STREET LIGHTING PLANS

FED. RD. DIV. NO.	PROJECT NO.		SHEET NO.	
6	(See Title Sheet)		836	
STATE	STATE DIST. NO.	COUNTY		
TEXAS	18	ROCKWALL		
CONTROL	SECTION	JOB	HIGHWAY NO.	
0451	01	032	SH 205

56 Change Order

FED. RD. DIV. NO.	PROJECT NO.	SHEET NO.	
6	(See Title Sheet)	837	
STATE	STATE DIST. NO.	COUNTY	
TEXAS	18	ROCKWALL	
CONTROL	SECTION	JOB	HIGHWAY NO.
0451	01	032	SH 205

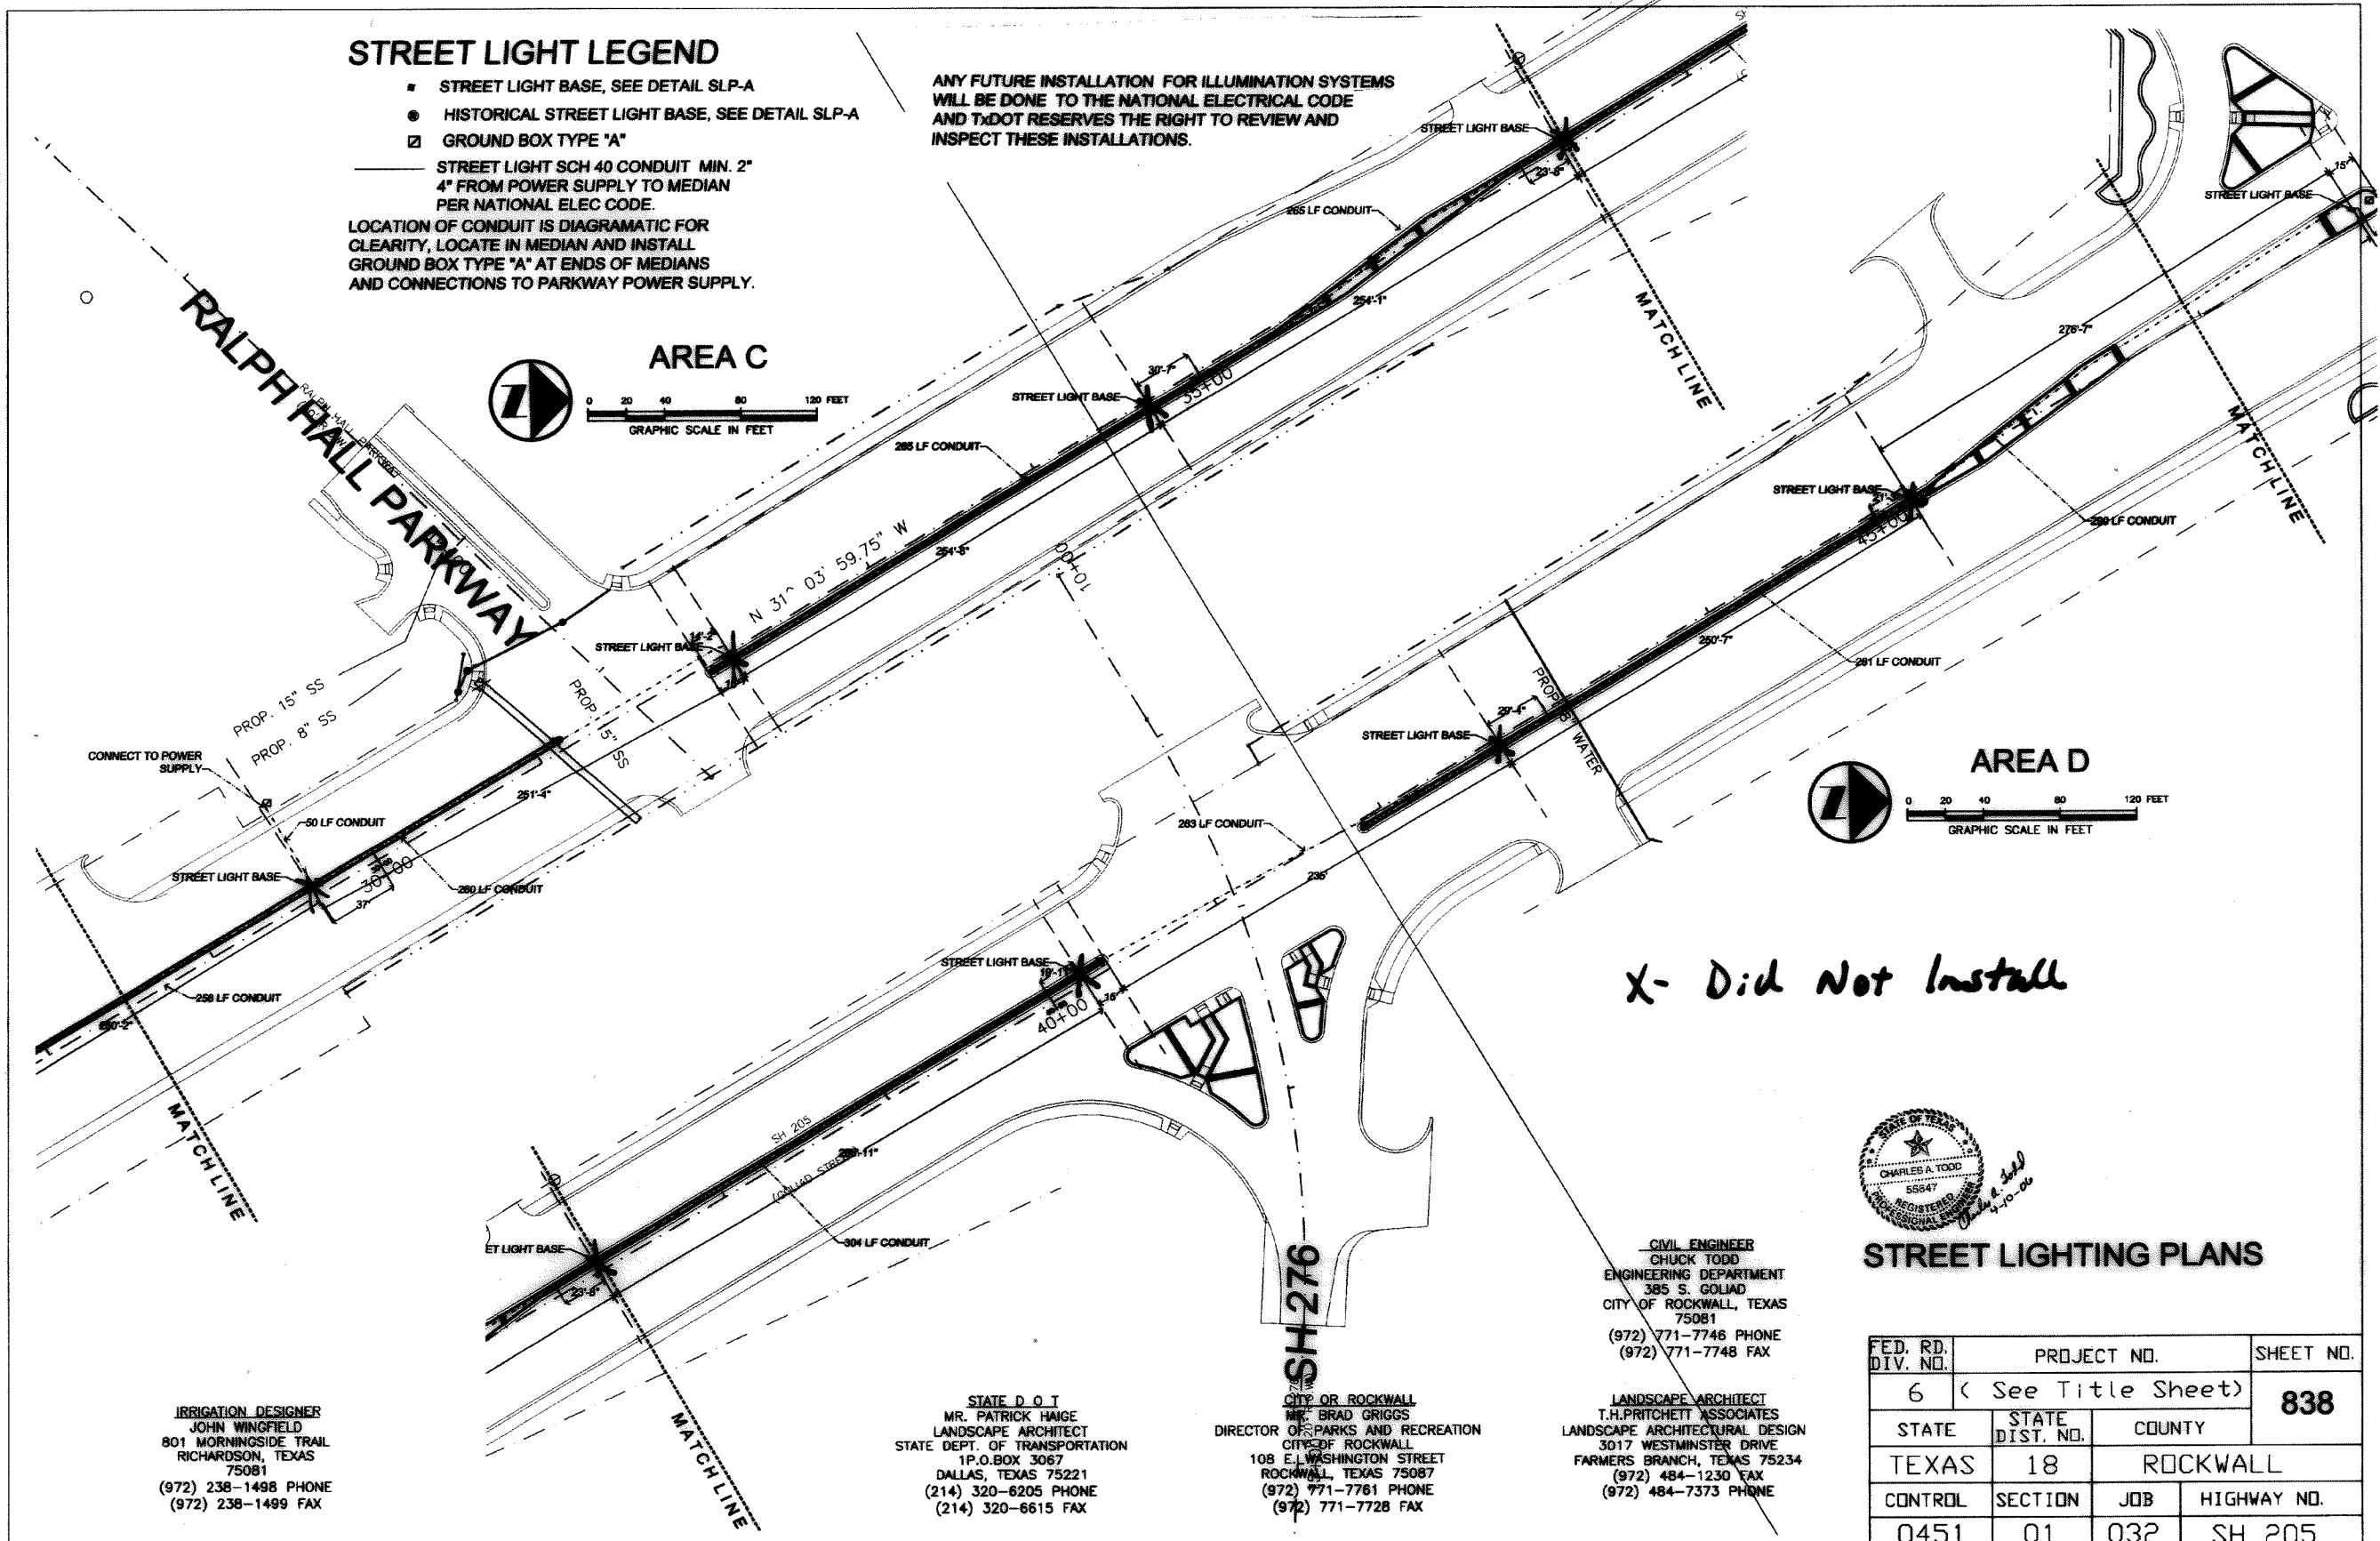
X- Did Not Install

FED. RD. DIV. NO.	PROJECT NO.	SHEET NO.	
0451	01	839	
STATE	STATE DIST. NO.	COUNTY	
TEXAS	18	ROCKWALL	
CONTROL	SECTION	JOB	HIGHWAY NO.
0451	01	032	SH 205

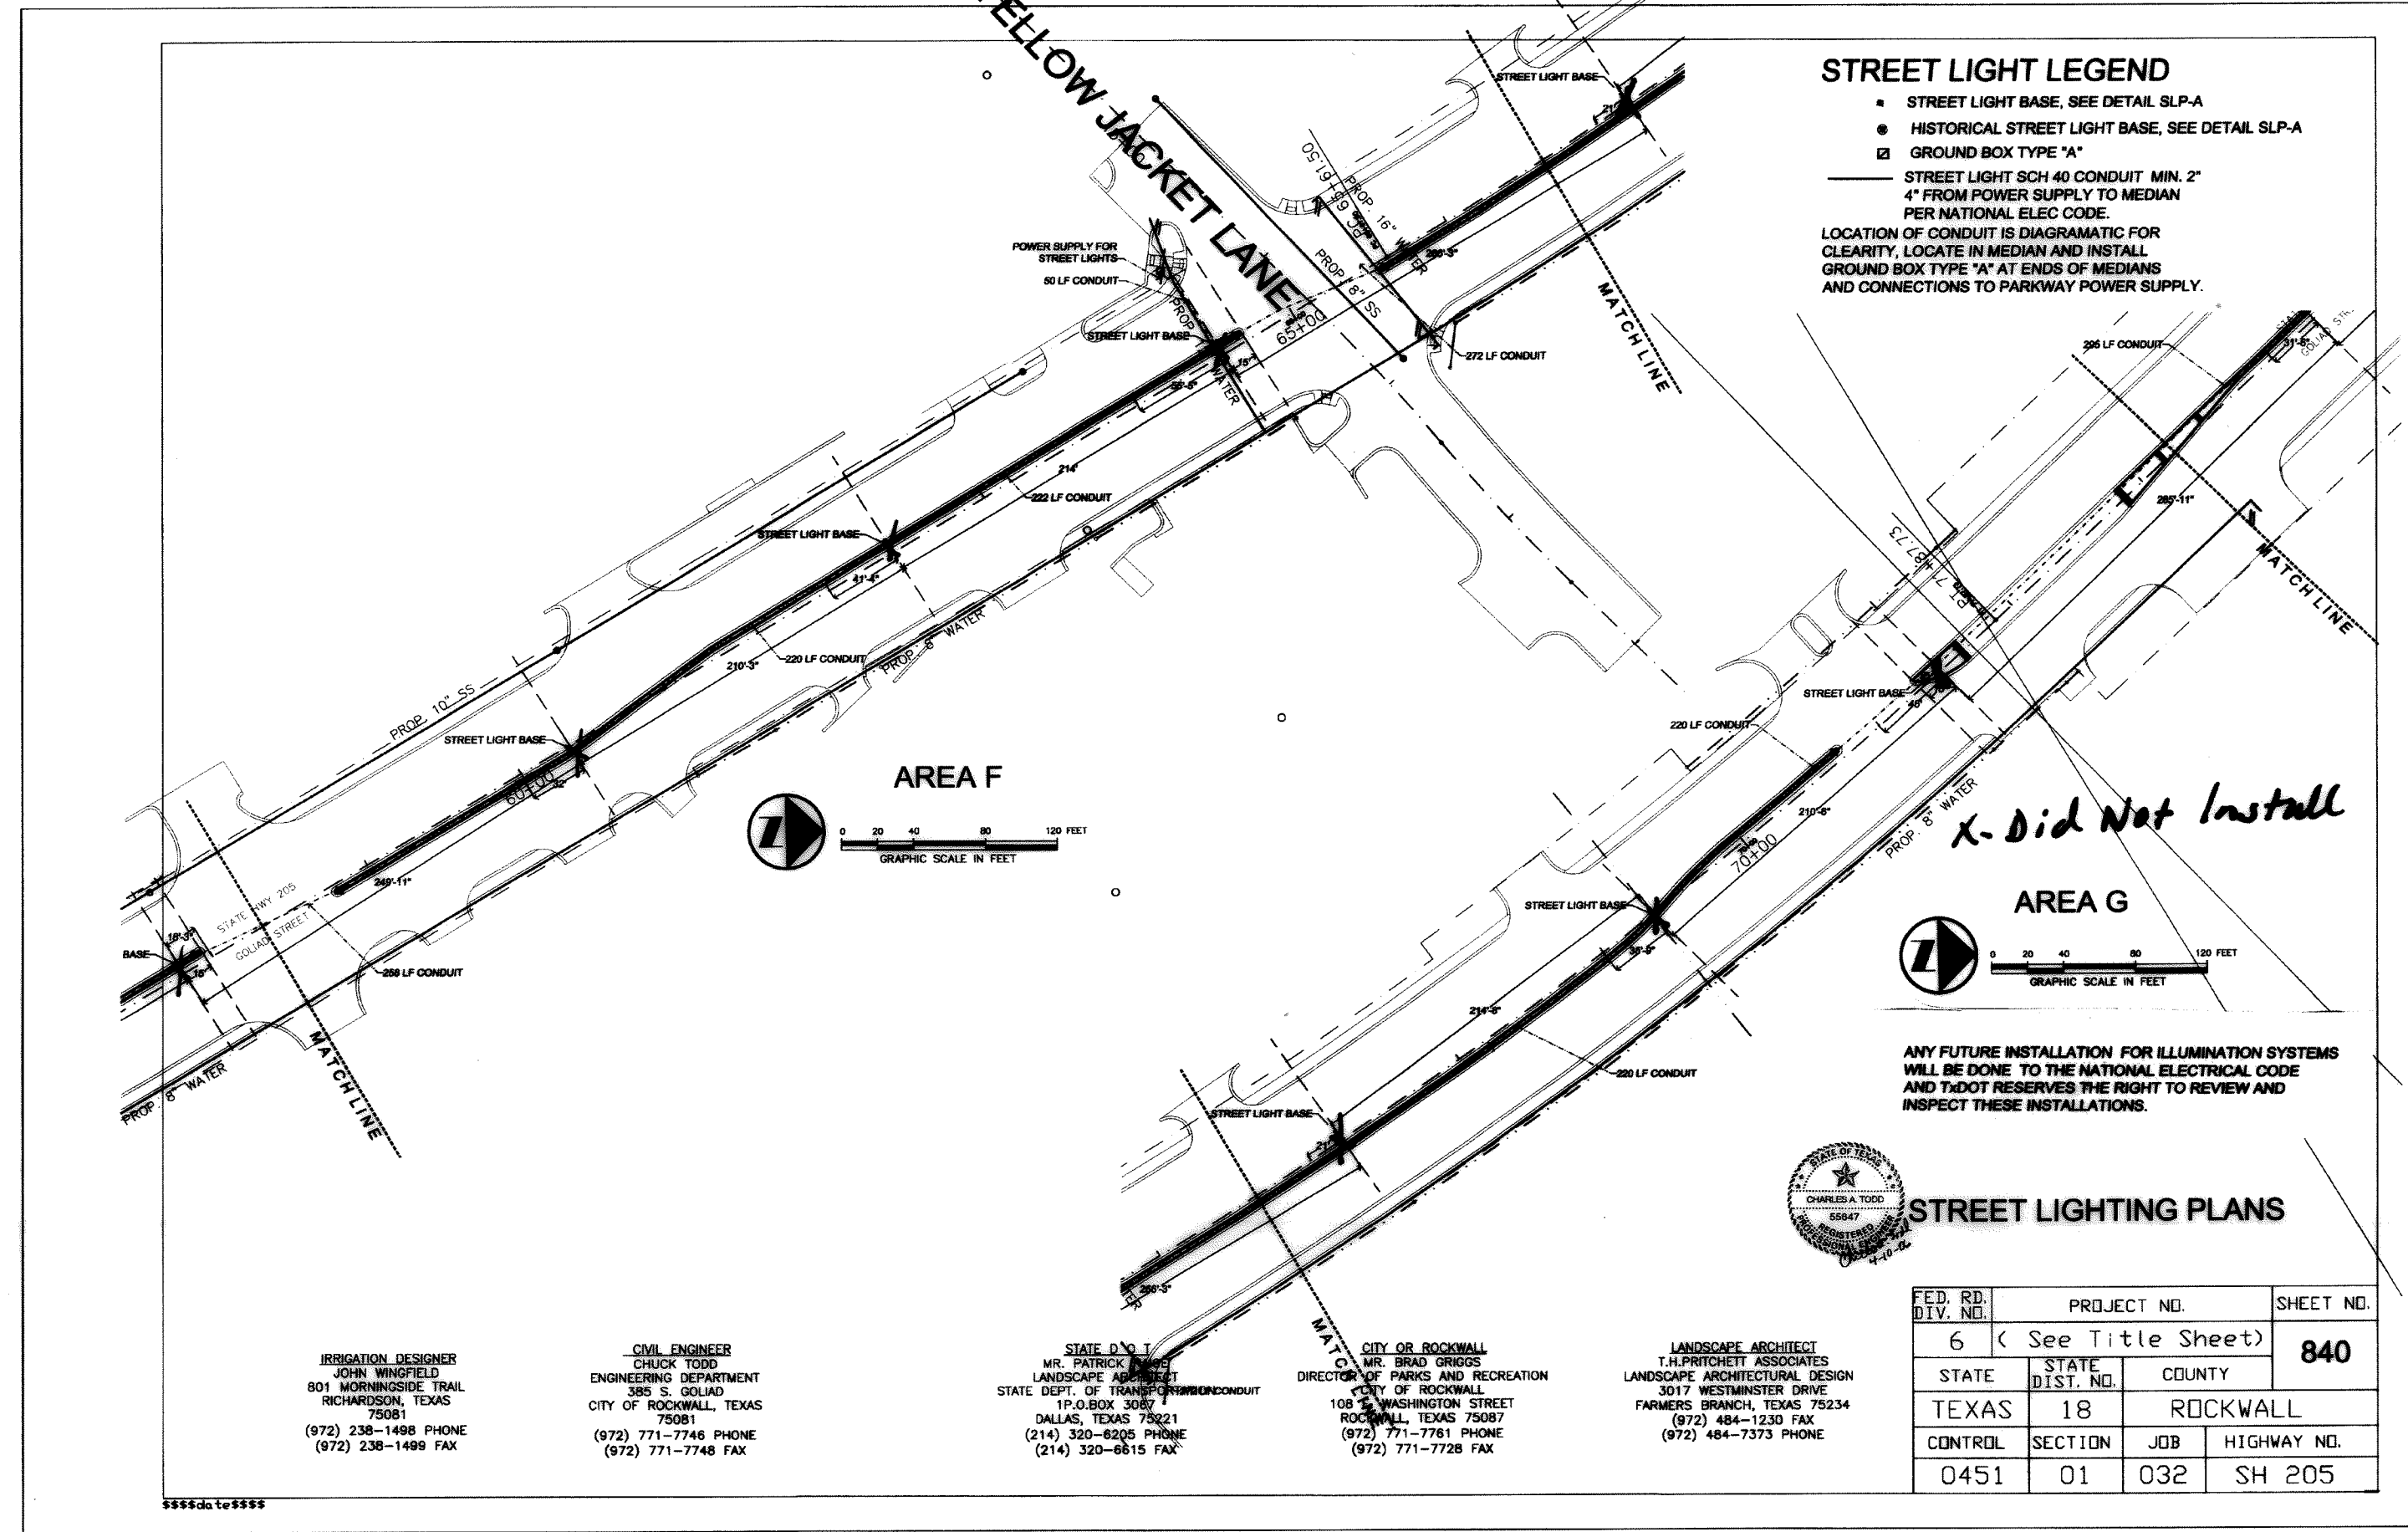
X- Did Not Install

FED. RD. DIV. NO.	PROJECT NO.	SHEET NO.	
6	(See Title Sheet)	840	
STATE	STATE DIST. NO.	COUNTY	
TEXAS	18	ROCKWALL	
CONTROL	SECTION	JOB	HIGHWAY NO.
0451	01	032	SH 205

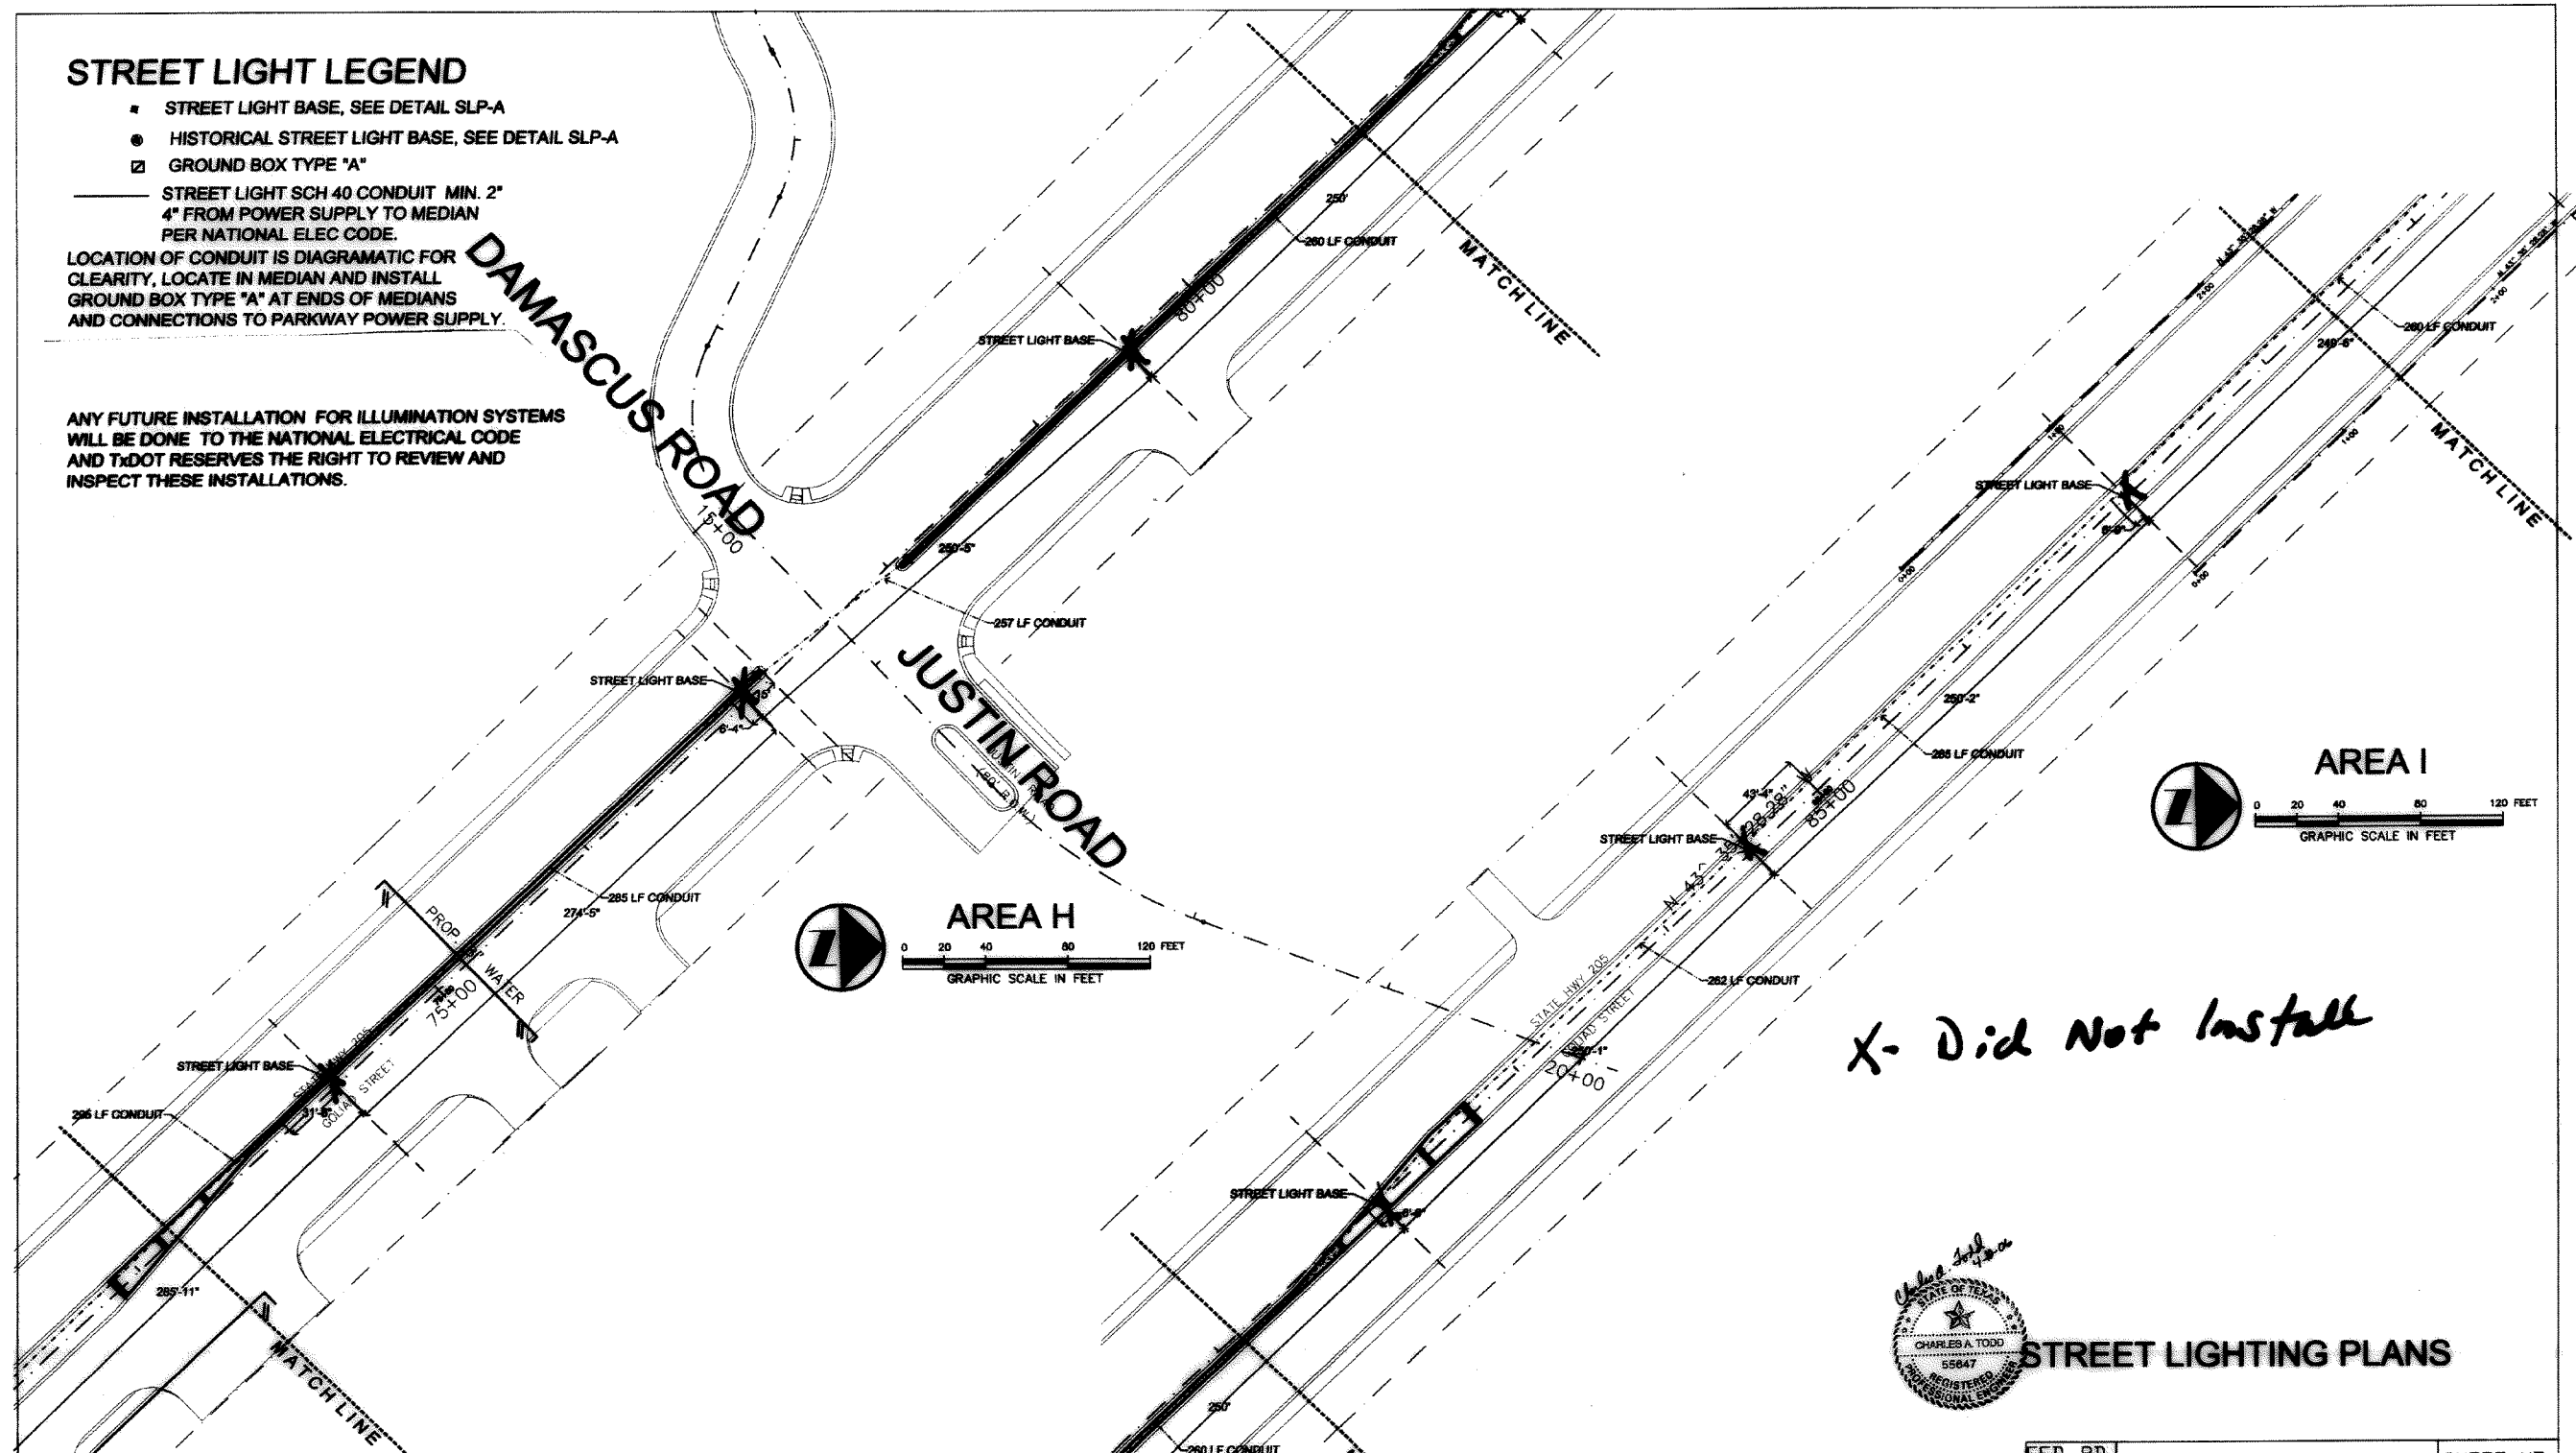
X-Did Not Install
